## Landscape Referral Response

<b>Application Number:</b>	Mod2023/0479
<b>Date:</b>	10/11/2023
<b>Proposed Development:</b>	Modification of Development Consent DA2021/2034 granted by the Land and Environment Court for demolition works and construction of a residential flat building
<b>Responsible Officer:</b>	Thomas Prosser
<b>Land to be developed (Address):</b>	Lot 50 DP 705739 , 30 Fairlight Street FAIRLIGHT NSW 2094

Figure 1 below:

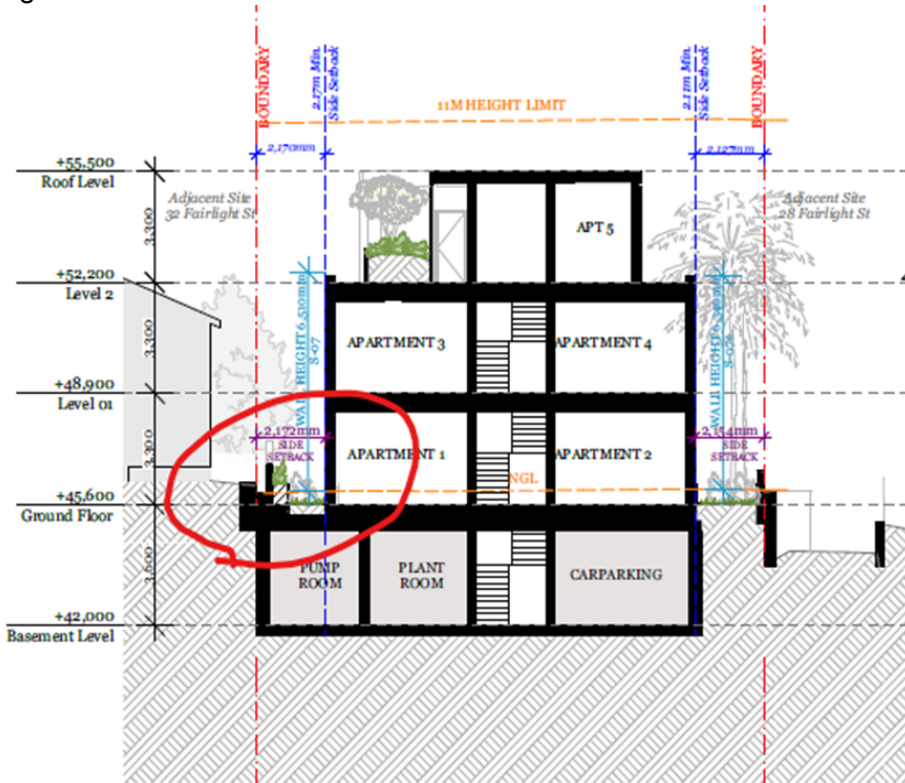
Landscape Referral raise no concerns for items 1, 2, 4, and 5 as listed above. However Landscape Referral do not support the item 3 as listed above.

The approved Court landscape outcome includes soil within planters over structure, to apartment 1 ground level, as illustrated in figure 1, and there is no valid reason to alter this. As such the Court

approved landscape outcome (over structure ie. OSD tank) as illustrated in figure 2 shall remain, and conditions shall be imposed.
